# 2022 TMS 402/602 Committee Proposed Change to Masonry Standard

Committee: Main Committee		Ballot #: 22
Item #: 22-PR-001		
Technical Contact/Email:	Arturo E. Schultz <a href="mailto:arturo.schultz@utsa.edu">arturo.schultz@utsa.edu</a>	
Draft Document Dated:	4/1/2022	
Reballot of Main Committee Item No.:	Response to TAC Comment No.:	Response to Public Comment No.:

Reference <i>(Choose from Drop-Down Menu)</i>	Section/Article
TMS 402 Commentary Section	10.5.3

**13.3 Adhered Veneer**

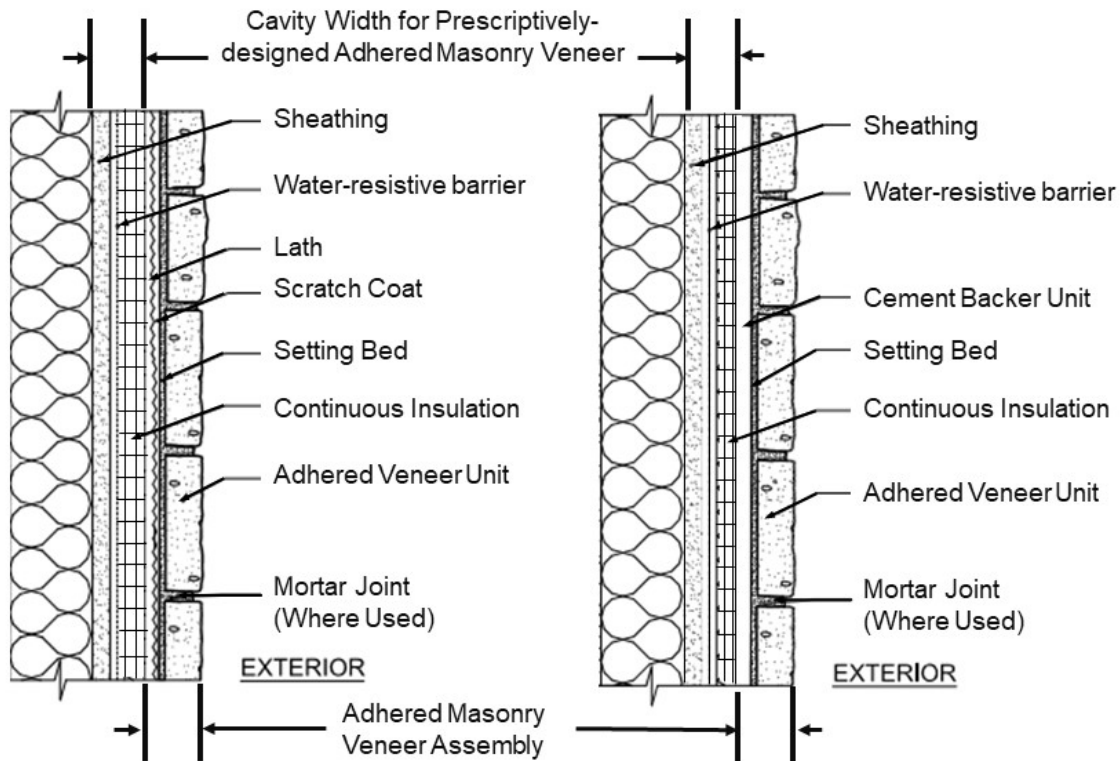
Figure CC-13.3-1 was added via Ballot Item 21-VG-041-042-184; however, some lines were not readable. In addition, there was no subheading for each of the two details. This ballot item corrects the lines and adds subtitles to the figure to identify each of the applications.

(a) with lath

(b) with cement backer unit
